**TRANSMITTAL OF COMMENT RESPONSE PACKAGE FOR THE
THORIUM/PLANT 9 IMPLEMENTATION PLAN**

**DOE-07776-97
DOE-FEMP EPAS
65
RESPONSES**

**THORIUM/PLANT 9 COMPLEX
IMPLEMENTATION PLAN**

COMMENT RESPONSE PACKAGE

FIGURE 1-1 Thorium/Plant 9 Complex Project Area

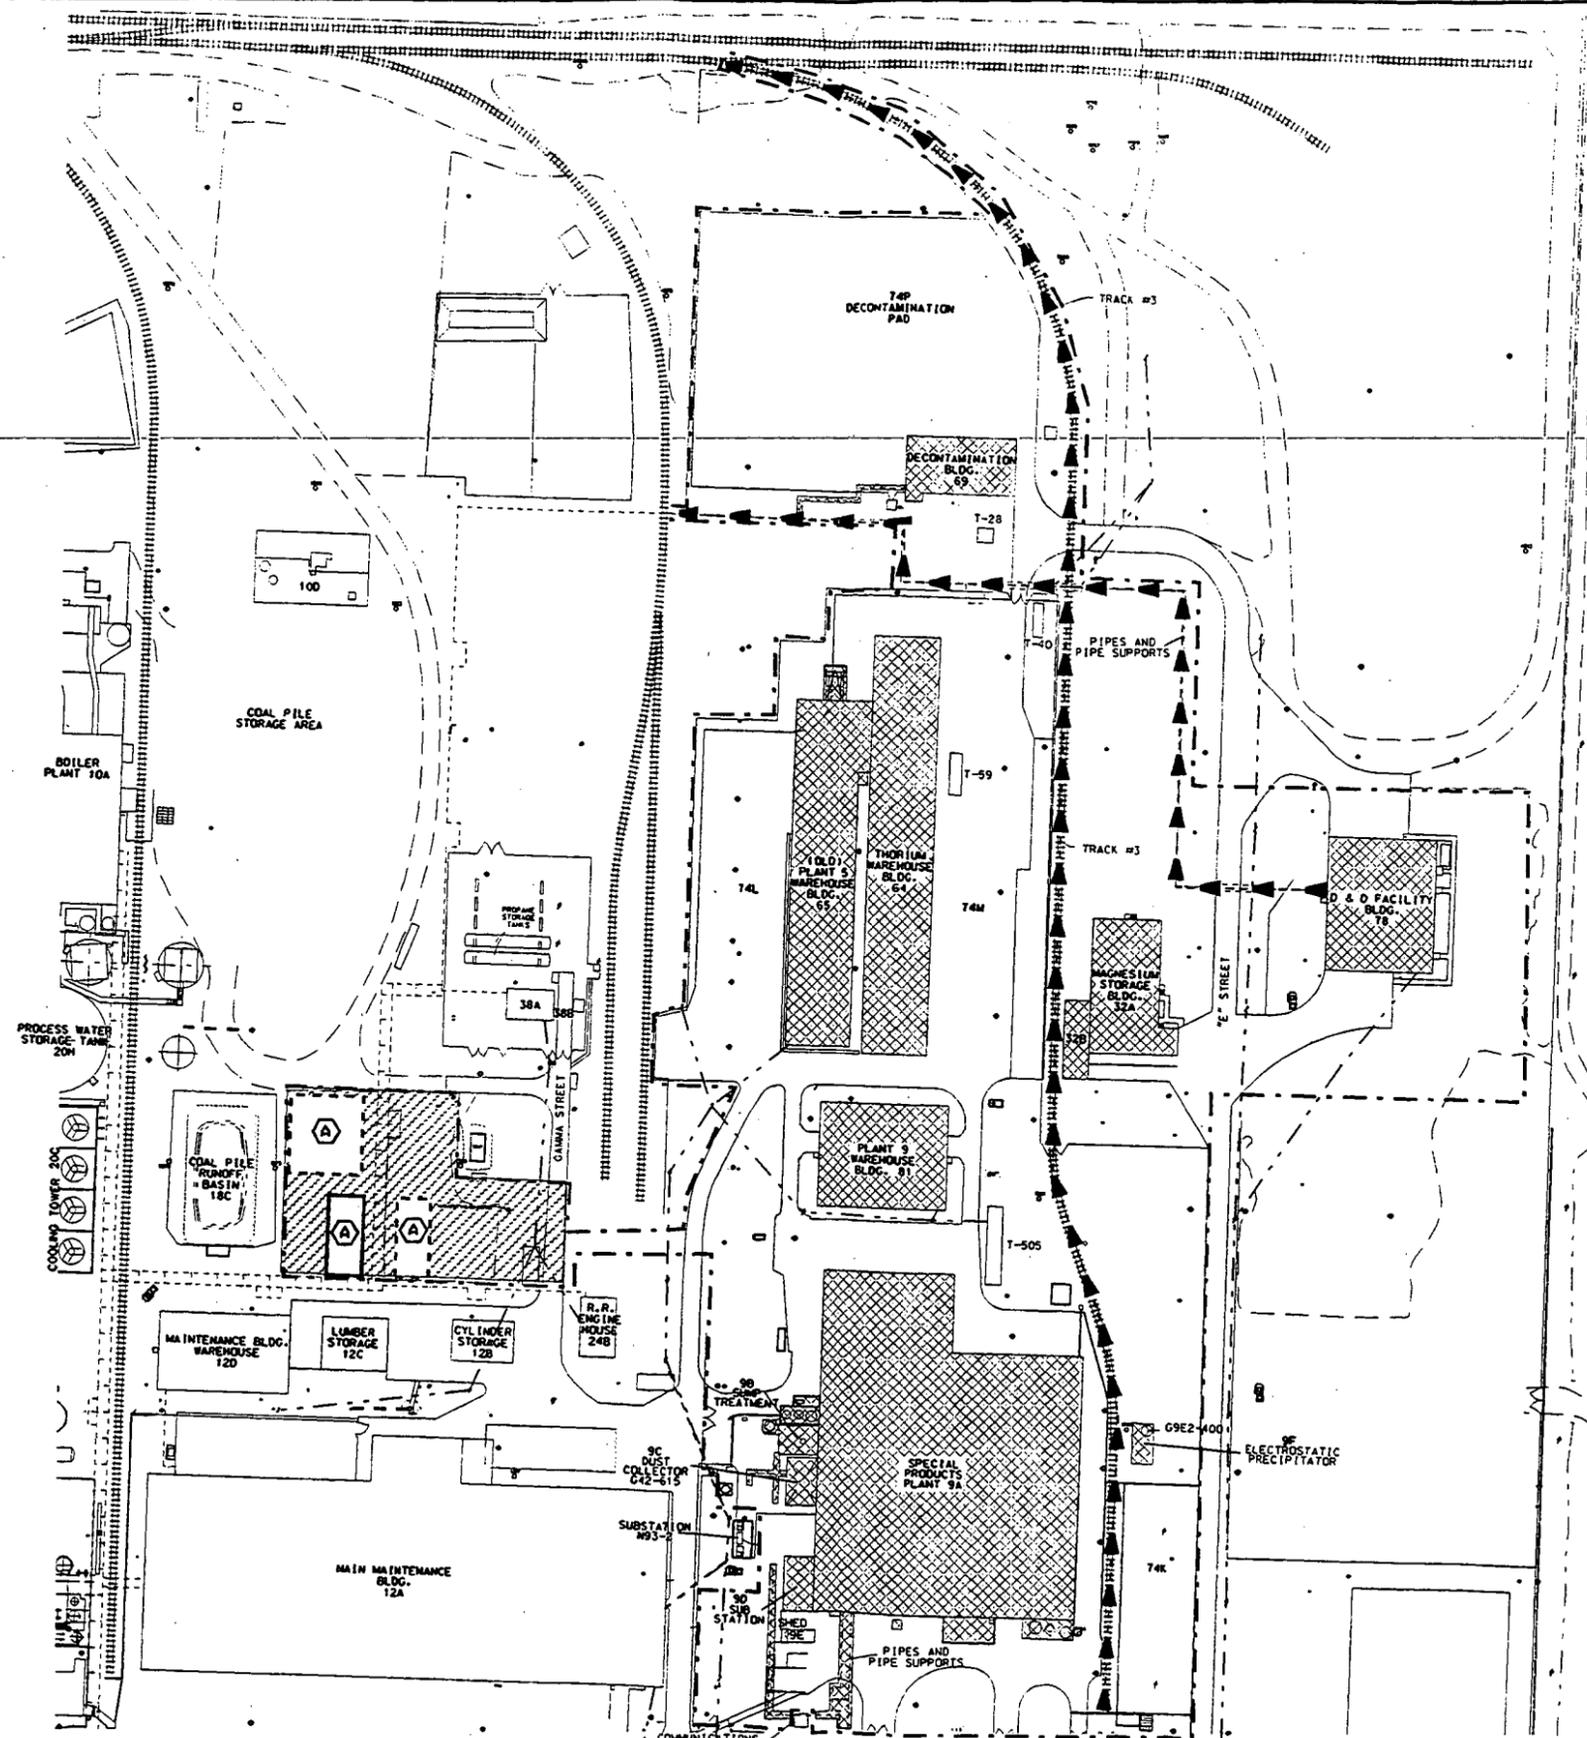
The text [Section 1.2 and Figure 1-1; p. 2, lines 20-22] lists railroad tracks, process trailers, and pipe bridges as components of the Thorium/Plant 9 Complex. However, these components are not clearly shown in Figure 1-1. Figure 1-1 should be revised to show all components of the Thorium/Plant 9 Complex.

[Re: Figure 1-1; p. 5] Figure 1-1 shows a site plan of the Thorium/Plant 9 Complex. Area F-3 of Figure 1-1 shows a cylindrical shed near the southwest corner of Building 9A and a building entitled "Building 9E" south of the southwest corner of Building 9A. However, the list of Thorium/Plant 9 Complex components on Page 2, Line 11, lists "Building 9E - Plant 9 Cylinder Shed," indicating that Building 9E and the cylindrical shed are the same. Either the text or Figure 1-1 should be revised to resolve this discrepancy.

[Figure 1-1; p. 5] Area F-3 of Figure 1-1 shows a structure entitled "Tank Curb & Stairs" that is to be demolished. However, this structure is not listed on Page 2 as a component of the Thorium/Plant 9 Complex. Either the text or figure should be revised to resolve this discrepancy.

[Re: Appendix D; Figure D-2] Figure D-2 identifies the buildings and structures to be demolished with a cross-hatched pattern. Building 9E, a gas cylinder storage shed located south of Building 9D, is not identified as a structure that will be demolished. The figure should be revised to include a cross-hatched pattern for Building 9E.

Agree. Although railroad tracks and pipe bridges were labelled, the copy quality of Figure 1-1 in the draft implementation plan did not allow a clear view of them. Figure 1-1 was updated to be consistent with recent Request For Proposal revisions and was revised to clearly identify all items included in the project and is included in Section 3 of this document.

Agree. The structure located and connected to the southwest corner of Building 9A is also a cylinder storage shed, although considerably smaller in dimensions. That structure is not listed as a separate OU3 component because it is attached to and considered part of Building 9A. The label for that Building 9A appendage was removed from the revised figure to avoid confusion. Please refer to the revised Figure 1-1 included in Section 3 of this document.

Agree. Figure 1-1 was revised to address this comment and is included in Section 3 of this document. The Tank Curb & Stairs are no longer shaded since they are considered at- or below-grade.

Agree. Figure D-2 was revised to address the comment. Component 9E (the small rectangle located at the west end of a larger rectangular area) has been shaded. The larger rectangular area is a concrete slab situated at- and below-grade. Since Figure D-2 is identical to Figure 1-1, please refer to the revisions made to Figure 1-1, which is included in Section 3 of this document.

FIGURE 2-1 Proposed Air Monitoring Locations for Thorium/Plant 9 Complex

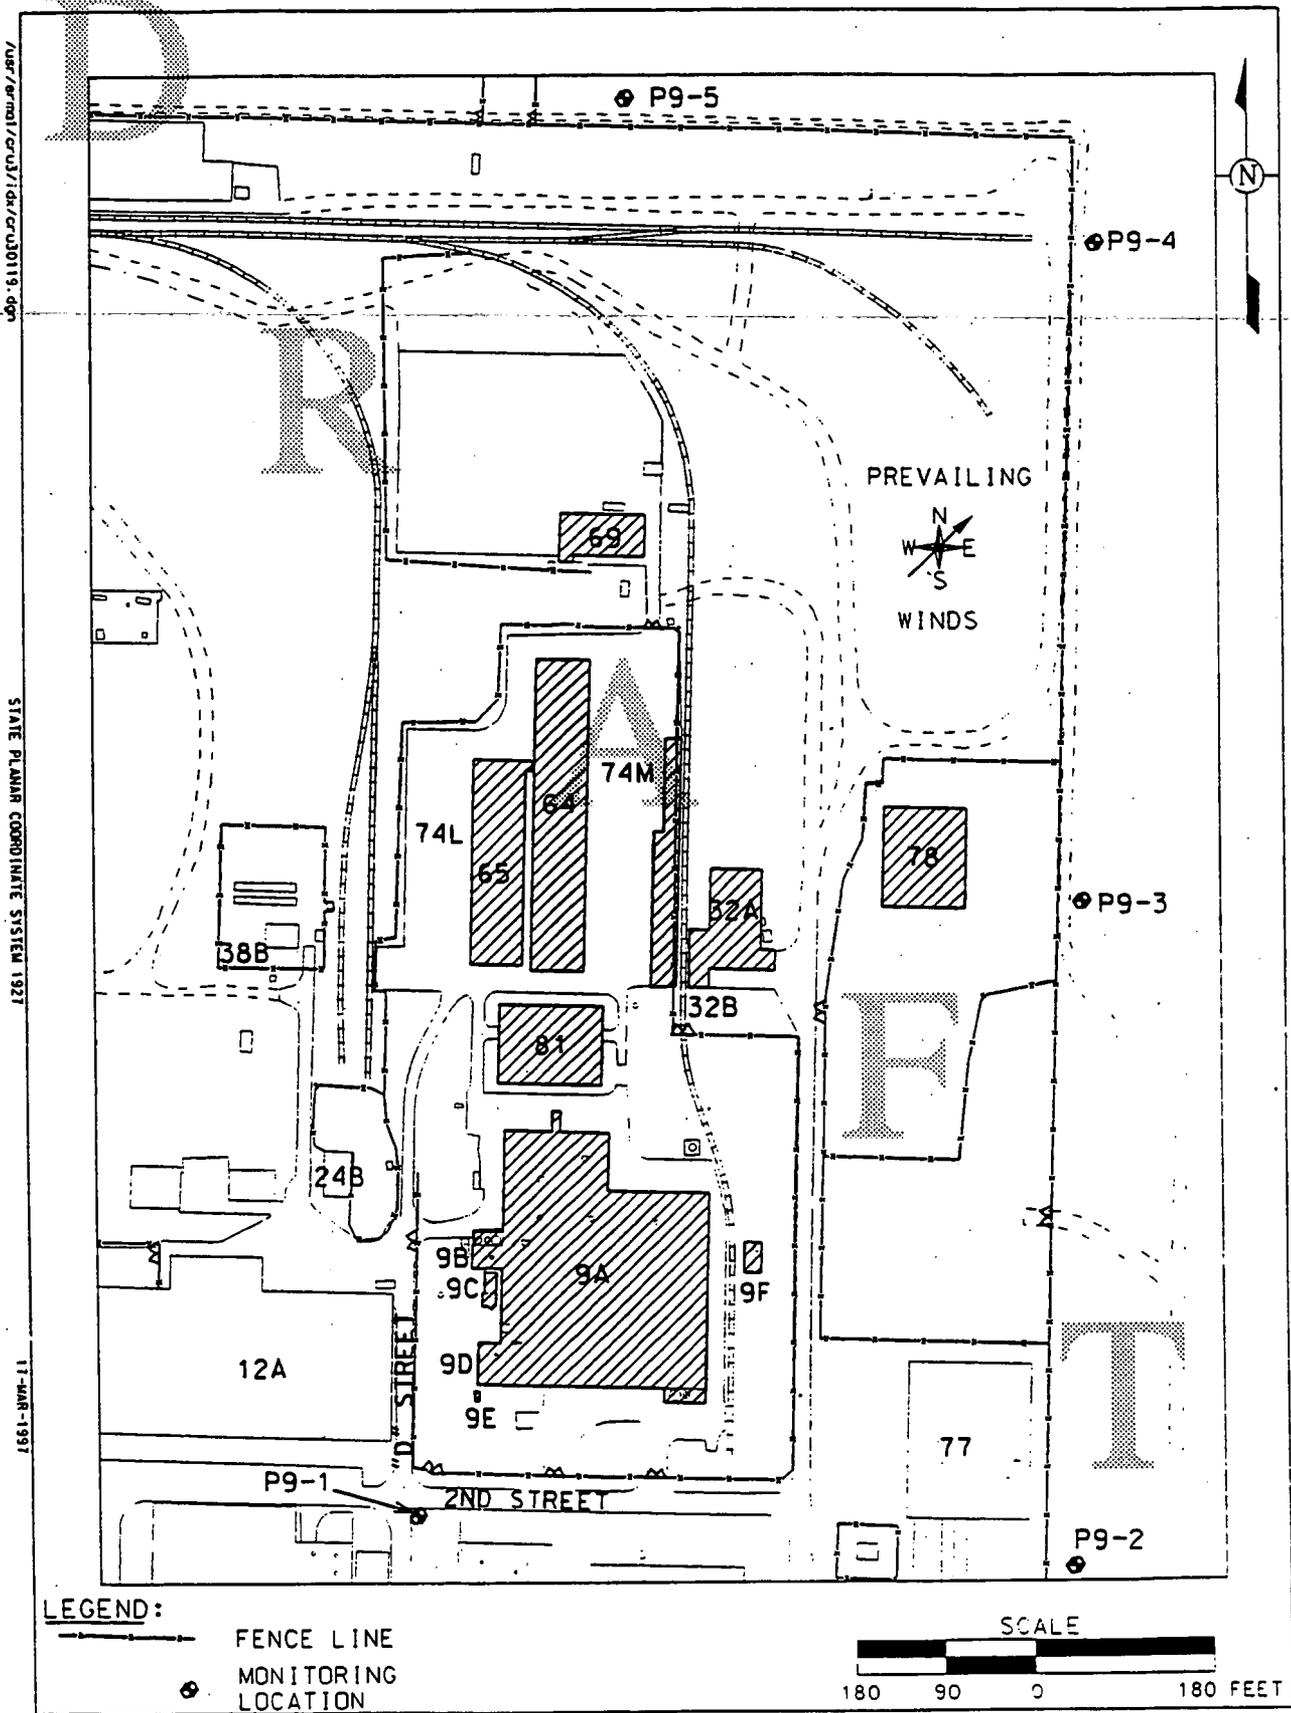
[Re: Figure 2-1] Figure 2-1 shows the proposed supplemental air monitoring locations for the Thorium/Plant 9 Complex. Figure 2-1 shows that no air monitoring location is present along the western side of the Thorium/Plant 9 Complex. The implementation plan should be revised to explain why no air monitors will be located along the western side of the Thorium/Plant 9 Complex.

[Re: Section 2.4, p. 19, Figure 2-1] Please provide a scaled drawing out to the fence line.

Agree. The location of monitors around the Thorium/Plant 9 Complex was based on wind rose data and modeling of potential atmospheric releases. The most potentially impacted vectors were identified for the placement of monitors and the least affected vector was selected for the upwind monitor location. None of the vectors in the western sector of the Thorium/Plant 9 Complex show historical significance, therefore no monitors were included in these locations. Please refer to the revisions shown on Page 24 (lines 2-8), which is included in Section 3 of this document.

Agree. Figure 2-1 has been revised to scale showing all pertinent air sampling locations. The revised figure is provided on Page 25, which is included in Section 3 of this document.
